Product Change Notification

PCN-ICC-978-2017

Business Unit	Product Line Code	Type of Change	Action	Date of Issue
ICC - Industrial Cabinet	BE2	Product Change Notification	Notify Distributors and Field	10/5/2017

Previous Product	New Product

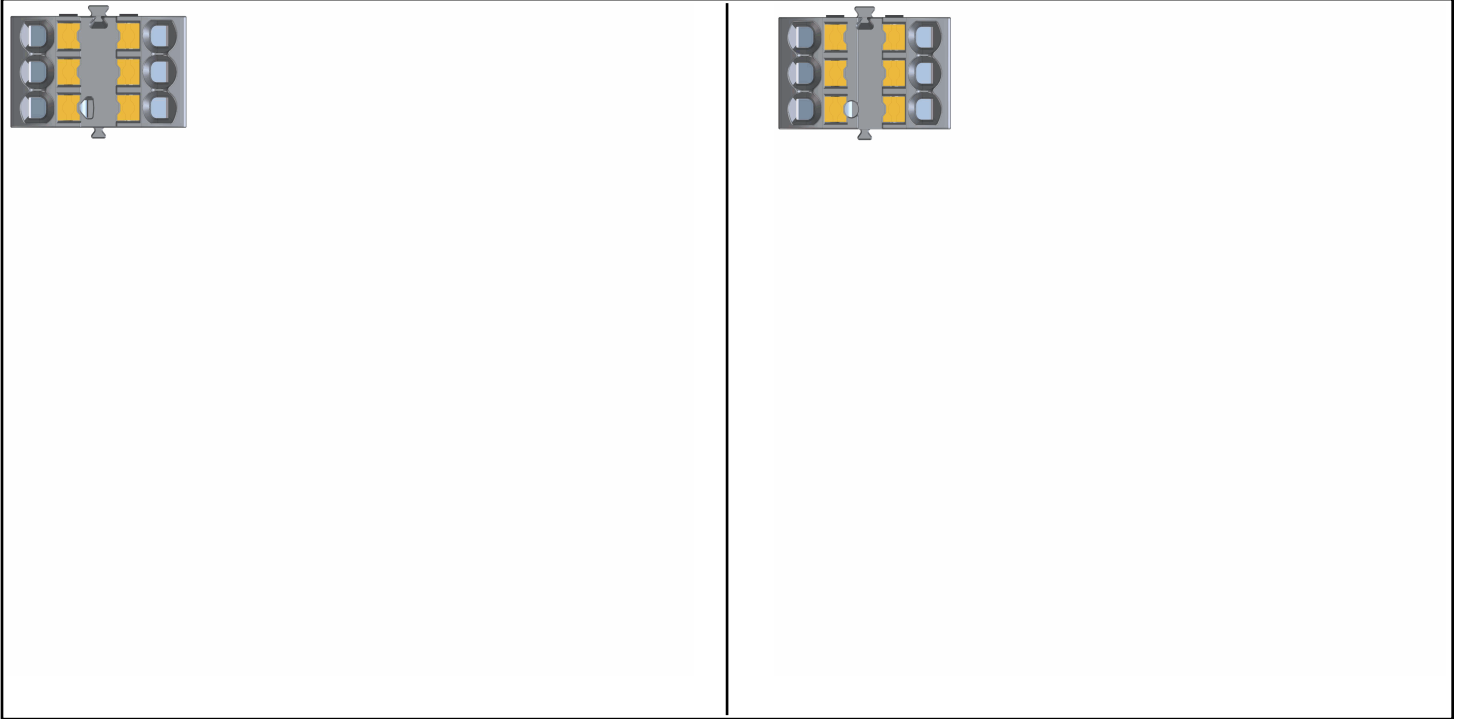
- Test hole will now be rounded to offer the same comfortable usage as standard PT terminal blocks
- Area around the test hole raised by 0.3 mm to enable proper application of marking material
- Combination key shortened by 1 mm to allow for easier connection and disconnection of blocks
